U. S. NUCLEAR REGULATORY COMMISSION
REGION I

Report Nos. 50-277/278/88-29

Facility Name: Peach Bottom 2 & 3

Inspection Summary: Inspection on August 5, 1988, August 8-12, 1988
(Report No. 50-277/278/88-29)

FIGURE 1
 EACH BOTTOM REACTOR VESSEL SECTION

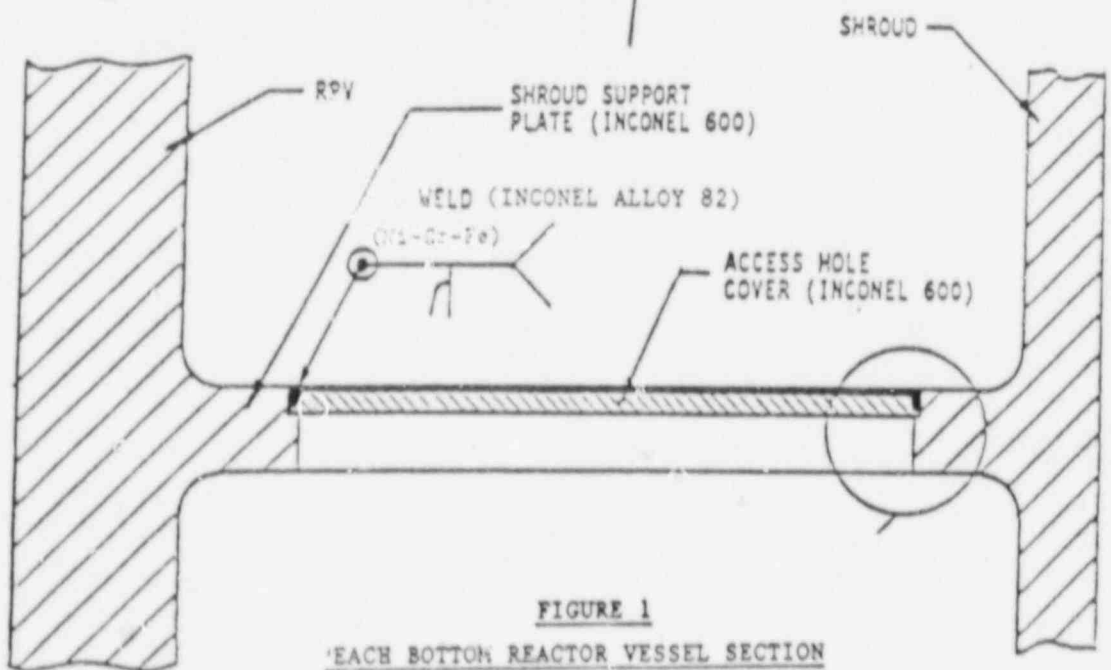
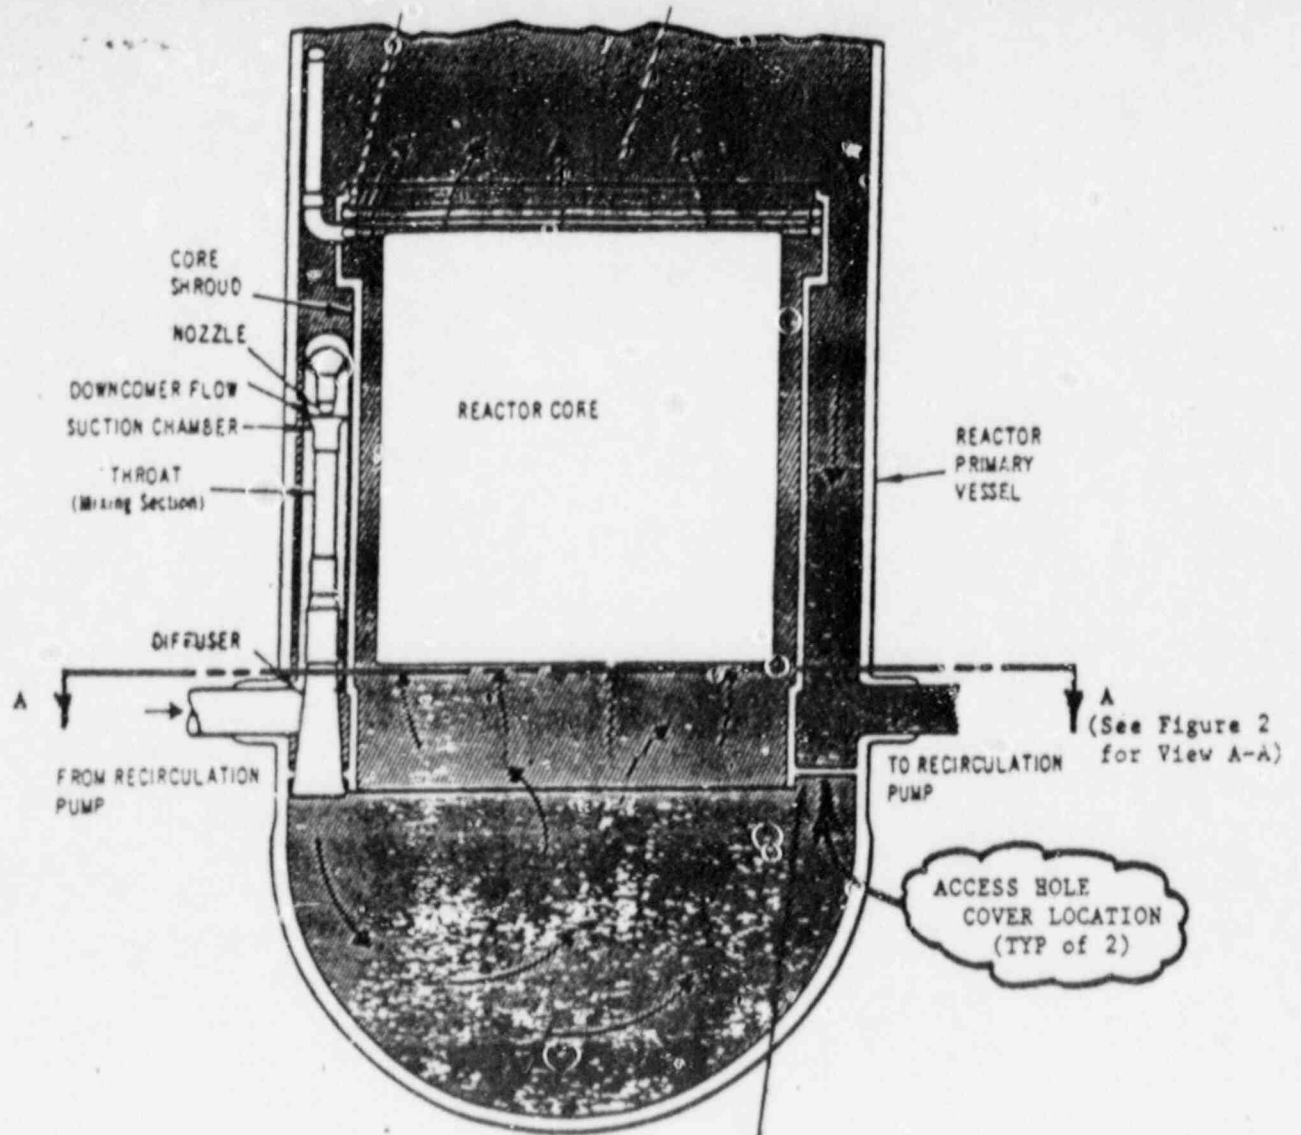
As reported in IR-88-08, January 1988, GE performed a remote, ultrasonic examination of two Inconel 600 shroud access hole cover plate welds (see figure 1) in the Unit 3 reactor vessel which were suspected of having intergranular stress corrosion cracking. The 21" diameter cover plates were welded to the shroud support plates with a "J" groove configuration (see figure 1) that resulted in a crevice in the weld joint. The UT examination which employed the GE Ultra Imager III instrument for data acquisition disclosed significant indications which GE interpreted to be due to intergranular stress corrosion cracks. The licensee questioned the validity of the test and requested that GE repeat the examination.

FIGURE 2

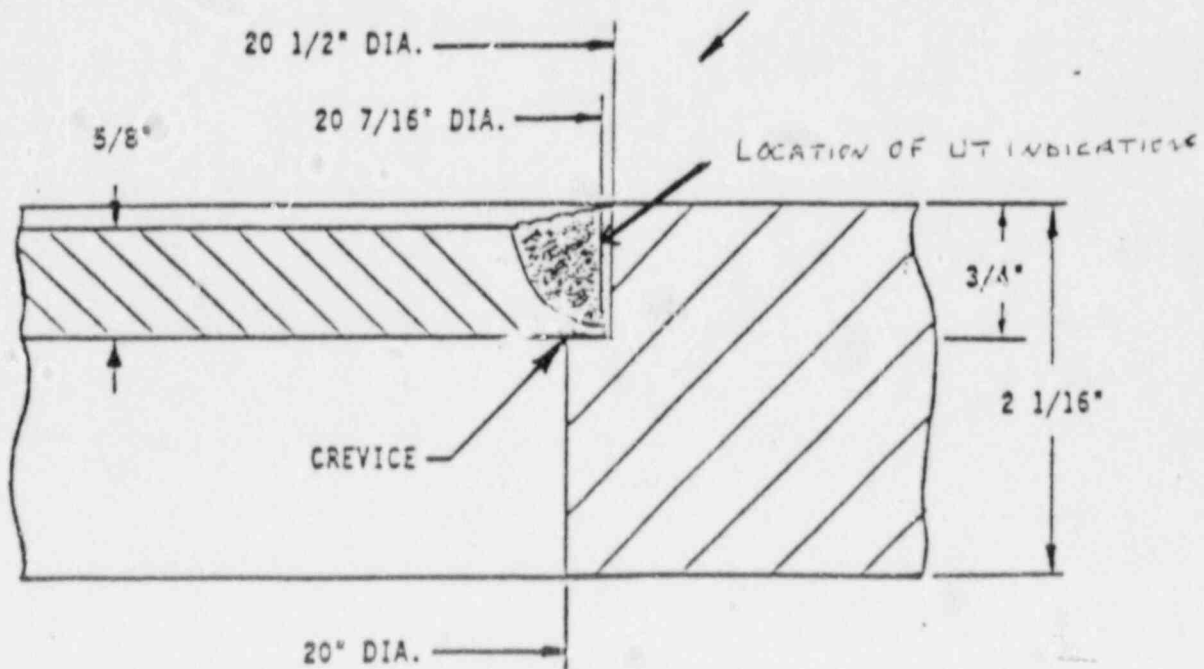
On August 6, 7 and 10, 1988, GE reexamined the 0° and 180° cover plate welds in Unit 3 using the same procedure and personnel employed in the examination of Unit 2. The inspector witnessed the calibration phase of the examination and found it to be in agreement with Procedure UT-57. The examination revealed significant indications located on the vertical fusion line along the shroud support side of the weld (see figure 2). The 0° cover plate weld indications were present 360° intermittently with an

average of 40% thru wall depth and with some areas showing 80% thru wall. The 180 cover plate weld showed indications intermittently 25% around the cover with an average of 20% thru wall depth and with areas showing up to 40% thru wall. The indications were confirmed by GE using a focused 65 refracted longitudinal search unit from the shroud side of the weld whereas the initial examination was performed from the access cover side.

The inspector and two regional inspectors reviewed the video tapes of the data and concurred with GE's findings with regard to the presence and location of the indications. Although GE stated that these indications are typical of intergranular stress corrosion cracks, the inspector and PE were of the opinion that the indications may also be related to other conditions such as cracking originating from root defects or lack of fusion along the side wall. The welds were reportedly made by the manual Tungsten Inert Gas process using Inconel 82 (ER NiCr-3) filler wire.

In anticipation of repairing the defective cover plate welds in Unit 3, the inspector reviewed a proposed GE repair procedure consisting of cutting out the existing cover plates and replacing them with new cover plates using a bolted connection. Other repair procedures are being considered by PE such as welding a strong back over the existing cover plates.
